**EUROPEAN INTEGRATED HYDROGEN PROJECT – PHASE II
(EIHP2)
Contract No. ENK6 – CT2000 - 00442**

**AGREED CHANGES INCLUDED IN
DRAFT ECE CGH₂ REGULATIONS (Revision 8 Dated 23.11.01)**

**AGREED MODIFICATIONS TO
EIHP DRAFT ECE COMPRESSED GASEOUS HYDROGEN (CGH₂) REGULATION Version 7 Dated 20.04.00
TO CREATE Version 8 Dated 23.11.01**

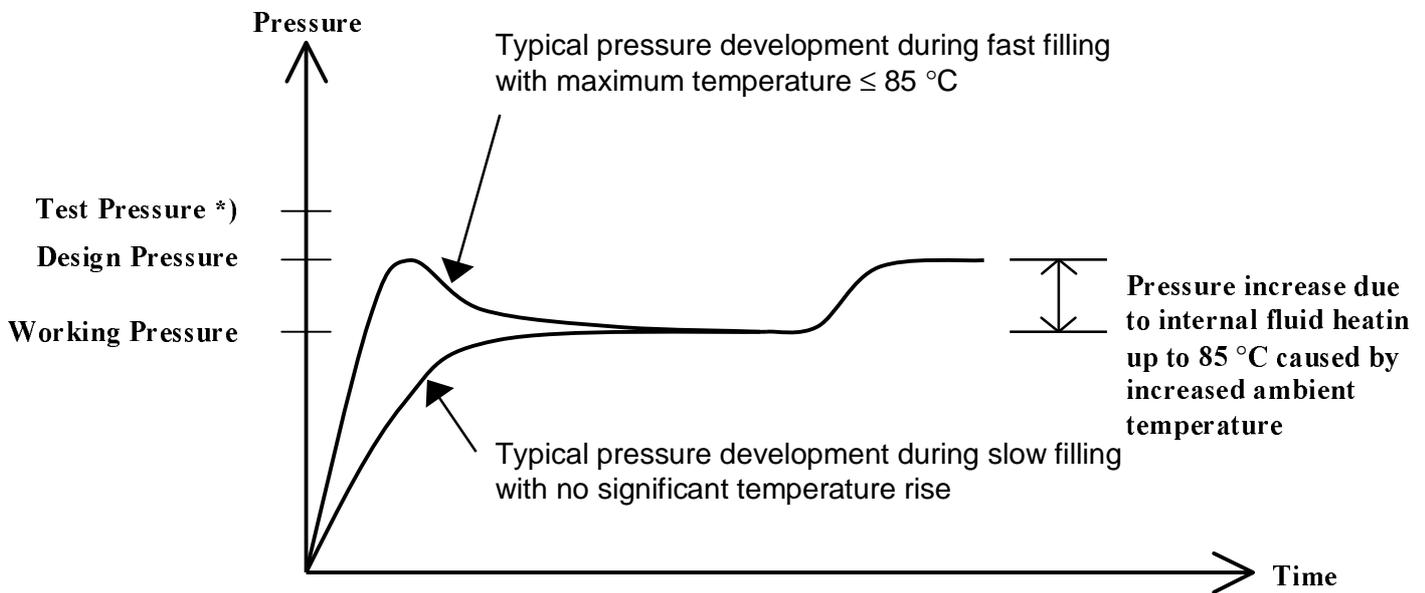
Annex7 – Appendix A – A.21	Permeation Test: Hydrogen has a larger atomic radius than helium resulting in a larger solubility and a smaller diffusivity than helium. One effect promotes permeation, the other declines it. It is therefore hard to judge, whether a permeation test performed with helium will lead to the same results as a permeation test performed with hydrogen. Should there be a different pass /fail criteria for hydrogen and helium? Use Ncm ³ instead of Nmi. Is the value 0.25 OK for hydrogen? Compare for instance with A.10 (0.004 Ncm3/hr).	Remove reference to hydrogen, change WP to design pressure and temperature
Annex 7, A.21	Clarified to refer to the container design.	
Annex7 – Appendix A – A.27		
Annex7 –	This will wind_up being a severe temperature cycle test. Also, I think this would be an	Change to Design Pressure
